1	02/13/14	REMOVED NORTH WALL/RE-ISSUED FOR CONSTRUCTION	MEN
0	01/07/13	ISSUED FOR CONSTRUCTION	JNM

CLIENT	CRIPPLE CREEK & VICTOR GOLD MINING COMPANY		
PROJECT	SQUAW GULCH VLF		
TITLE	NORTH TIMBER WALL PROFILE VIEW		
DESIGNED BY	CMT	CHECKED BY	JNM
DRAWN BY	CMT	APPROVED BY	JNM
FILENAME	1125GP105	DRAWING No.	A805
REV	1

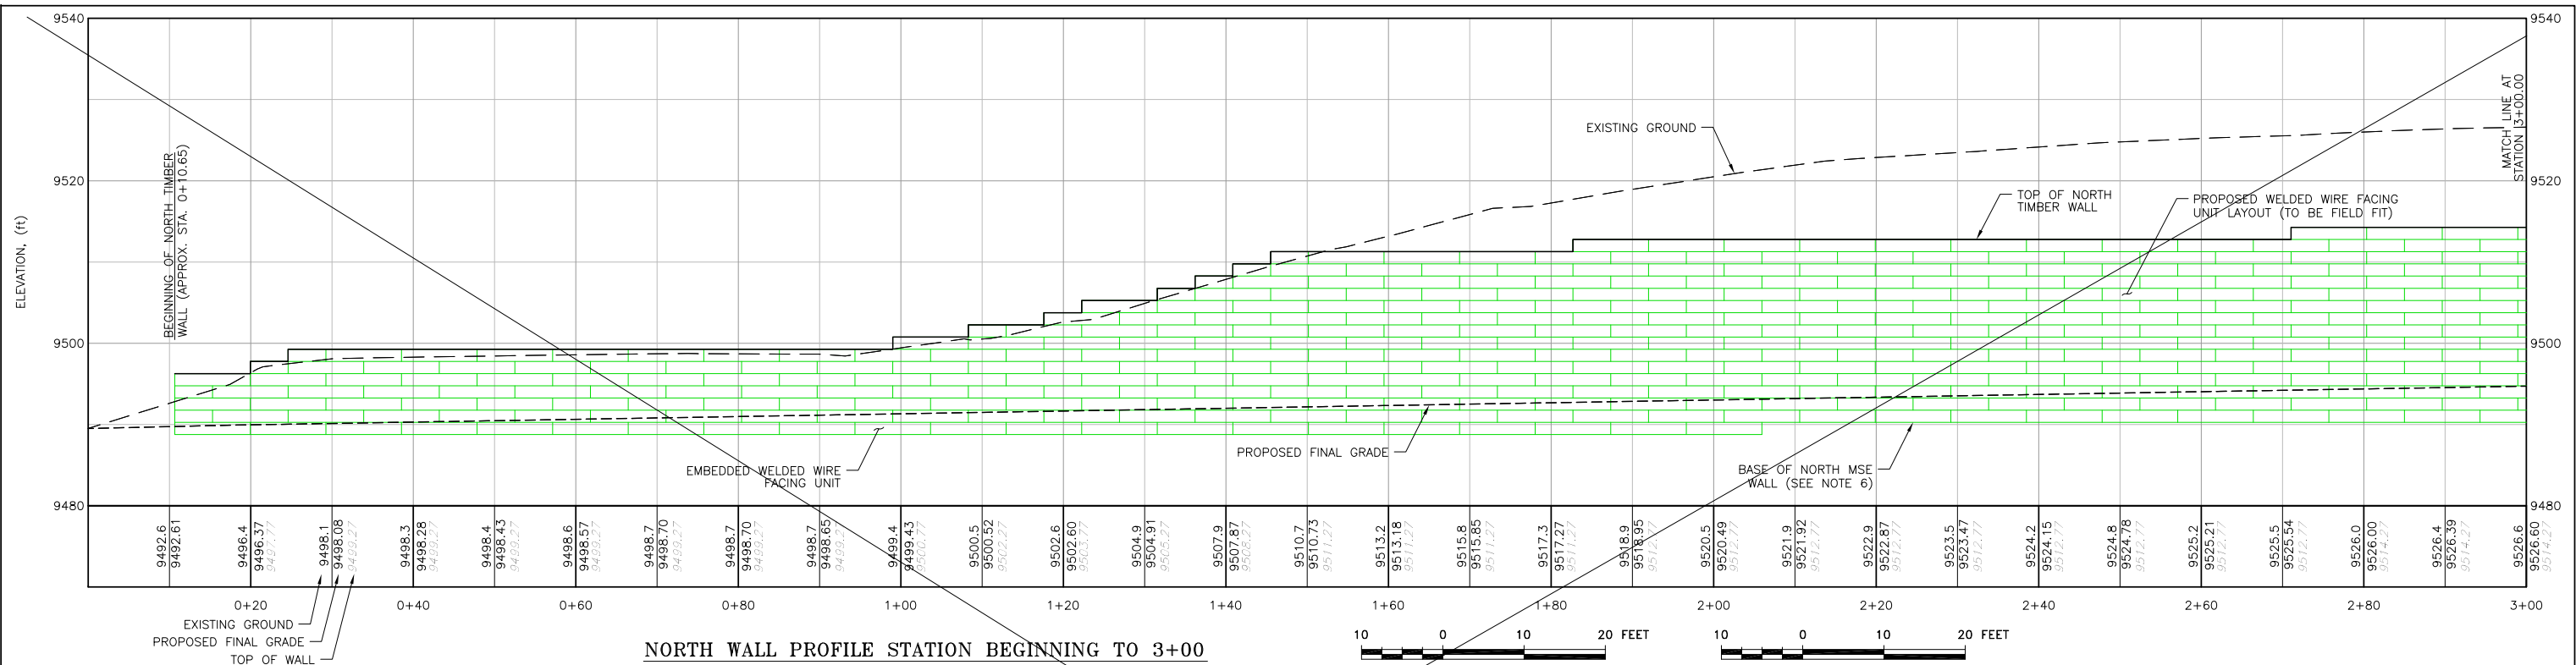
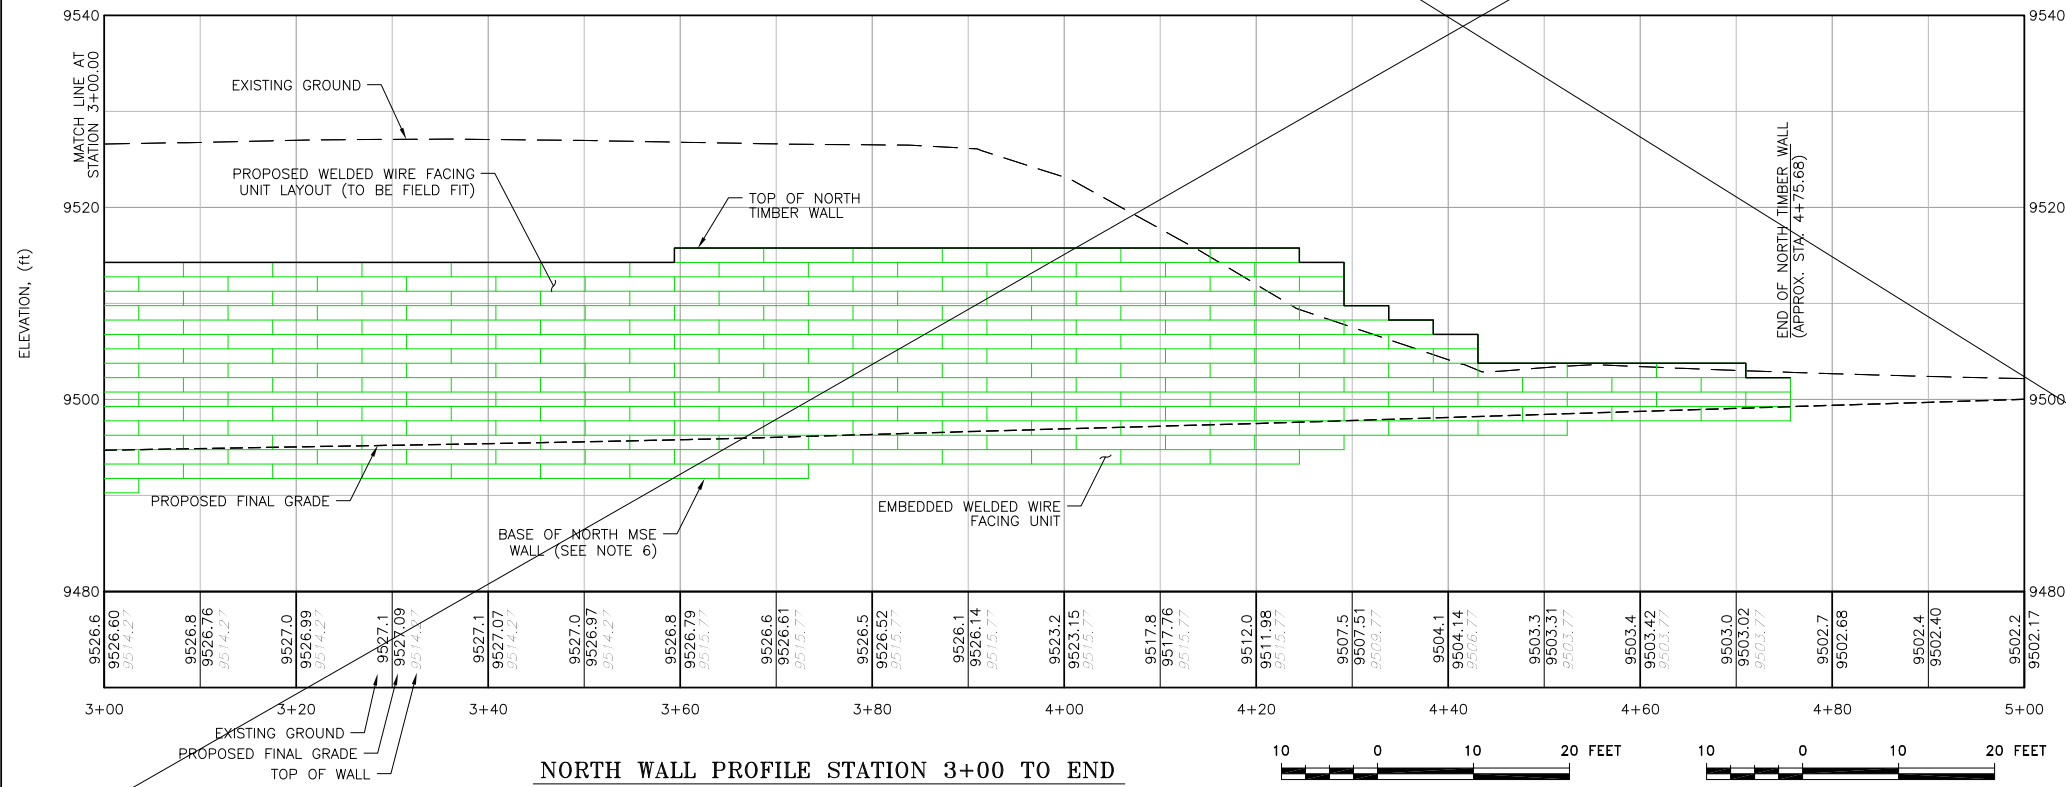
- THIS ENTIRE DRAWING HAS BEEN OMITTED IN REVISION 1 (2-14-14)
